#### TECHNICAL SPECIFICATIONS

# SERVICE BULLETIN

_			
	DATE 7 - 8 - 81	PRDDUCT C - 4000	PCB Phono

- la			
	DATE 10-13 - 80	PRODUCT C - 4000	PCB PWR AMP
- 1

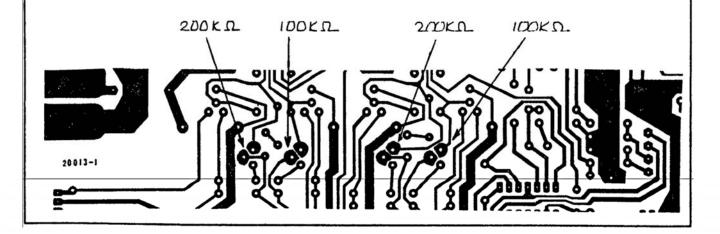
SERVICE PRIDRITY		All Units	
		Serial Nos. (specify)	
		RTS / Dealer Stock	
	<b>✓</b>	Specific Complaint TURN - OFF "SQUEAL"

ADD Z EA. IOOKIL AND ZOOKIL RESISTORS TO PROVIDE LOCAL NEGATIVE FEEDBACK, STABILIZE PWR AMP AT LESS THAN FULL SUPPLY VOLTAGE.

- I. REMOVE TOP AND BOTTOM COVERS.
- 2. PLACE UNIT ON ITS RIGHT SIDE W / OPEN RUTTUM FACING YOU.
- 3. LOCATE FOIL SIDE OF PWR AMP PLB. BOARD MUUNTED BEHIND VOLUME AND BALANCE POTS.
- 4 LOCATE FOIL PADS OF PREDRIVER TRANSISTORS SHOWN BELOW.
- 5 TACK-SOLDER RESISTORS TO PADS SHOWN BELOW WITH LARGE CIRCLES.
- 6. REPLACE BUTTOM, REMOUNT 3 PCB'S BY THEIR RE-SPECTIVE ANGLE - BRACKETS, REPLACE TOP.

DATE 6-11-80	PRODUCT C-4000 PCB DLAY	
SERVICE PRIORITY	All Units Serial Nos. (specify)	
	RTS / Dealer Stock	
	V Specific Complaint TOD MUCH / TOO HITTLE EC	.11()

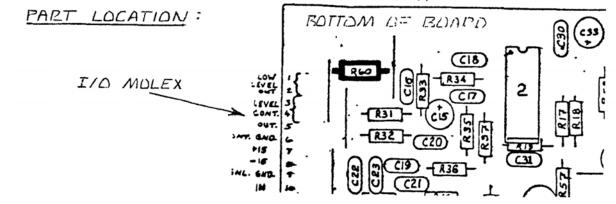
COMPLAINT: "TOO MUCH ECHO [HOWL]", OR "ECHO DEN - SITY CONTROL HAS TOO LITTLE [NO] EFFECT."

THE MAXIMUM GAIN OF THE DP-AMP WHICH FEEDS BACK DELAY SIGNAL [ RECIRCULATION ] IS FIXED BY DELAY PUR RESISTOR REO, NOMINAL 9.1 KO [ SEE DELAY SCHEMED].

- 1. CHANGE ROO [9.1K] TO 6.8KM. VERIFY AUDIBLE ECHO RECIRC. RUT NO HOWL AT FULL-CLOCKWISE ROTATION OF ECHO DENSITY POT.
- 2. IF HOWL PERSISTS, GO TO NEXT-LOWER RESISTOR VALUE. 16 2K, 5 6KJ UNTIL HOWL CEASES AT FOW LOHO DENSITY.

- 1 CHANGE RED ESTAIN TO ISKE VERIEY AUDIME ECHO
- 2. IF ECHO REMAINS INADEQUATE, CHANGE PAD TO 30 KA, UR REMOVE RAD AND LEAVE DEF PUR. II-NECESSARY.
- 3. IF HOWL OCCURS WITSKIL, STEP WHILE DOWN UNTIL. HOWL STOPS AF FOW ECHO DENISITY.
